APPLICATION NO.	FILING DATE	FIRST NAMED INVENTOR	ATTORNEY DOCKET NO.	CONFIRMATION NO.
09/972,287	10/05/2001	James E. Nelson	14144	4864

Office Action Summary

DETAILED ACTION

FIG. 5

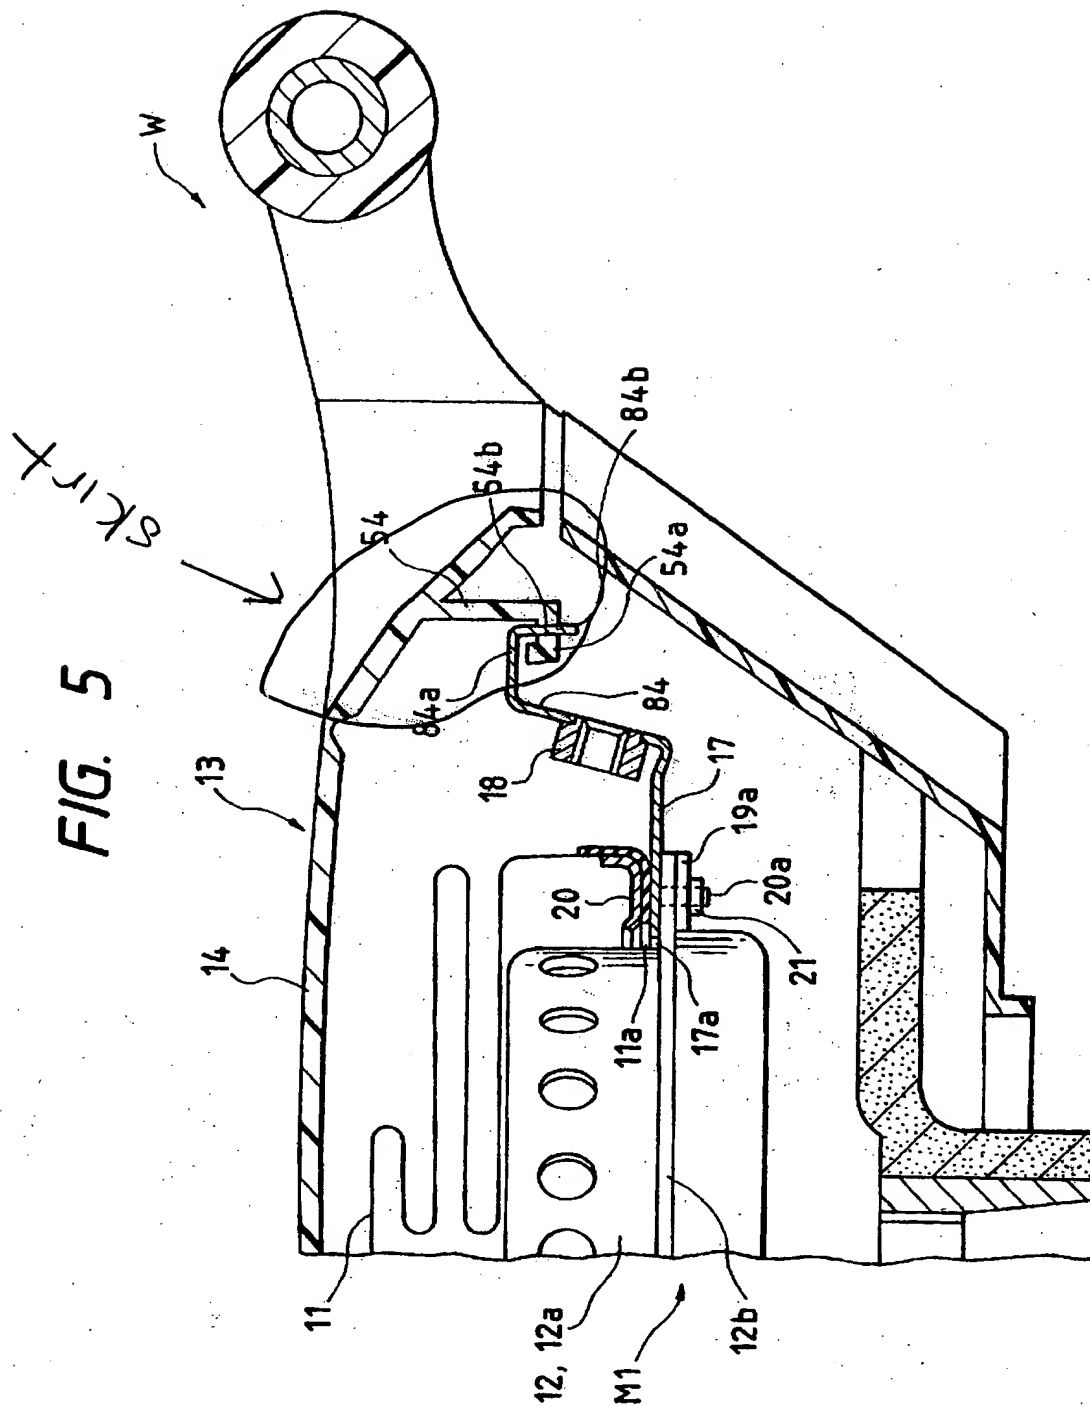
4. The text of those sections of Title 35, U.S. Code not included in this action can be found in a prior Office action.
5. Claims 1-4, 8, 9, 11, 15, 18-24, 29 and 32 are rejected under 35 U.S.C. 102(b) as being anticipated by Yamamoto et al. (US 5,794,968.) Yamamoto et al. teaches an airbag module including a cover (14) and a reaction housing (16, see Figure 6.) The reaction housing includes a plurality of mounting projections (83a, 83b, 84a, 84b) and an integral Z-height control tab (82a) whose top is parallel to the reaction surface (17, see Figure 6.) and the cover includes a plurality of windows (53a and 54b) in a skirt (please note that as broadly claimed, the skirt is considered to be all of the periphery of the cover that descends downward, and includes elements 51-54, and also the entire

downward extending edge of the cover- see attached marked Figures 5, and 8.) The mounting projections engage the window and define a Z-height (as seen in Figure 5) and the control tab engages the skirt and substantially maintains the height (as seen in Figure 4, the height of the bent portion of 82a is such that it allows little play in the slot 52.) Regarding claims 3 and 21, the angle is essentially 0°. Regarding claims 4 and 22, as broadly claimed, the tip of 82a is generally perpendicular to the bottom of the slot 52a (see Figure 4.) Regarding claims 9 and 24, the tab engages the skirt in a net fit (as taught in col. 5, lines 19-17, 82a fits into 52a because 52a is slightly bigger, additionally, the tab holds the skirt between itself and the bracket 19.) Regarding claims 8 and 23, the tab is made from thin sheet metal, and as such is capable of buckling. Please note that regarding claims 2, 20, and 32, Yamamoto et al. teaches that the reaction housing is metal (see col. 4, line 23.) The method of forming the reaction housing (stamping) is not germane to the issue of the patentability of the device itself. Therefore this limitation has not been given patentable weight.

withdrawn. However, upon further consideration, a new ground(s) of rejection is made in view of a different interpretation of Yamamoto et al. The Examiner has amended her rejection to consider a broader interpretation of skirt to include the entire section of the cover that surrounds and descends downwardly around the top portion of the cover, instead of the individual elements 53, 54. Additionally, the Examiner also notes that claims 18 and 32 do not include the limitation that the tab engages the skirt, but rather that the tab engages the cover.
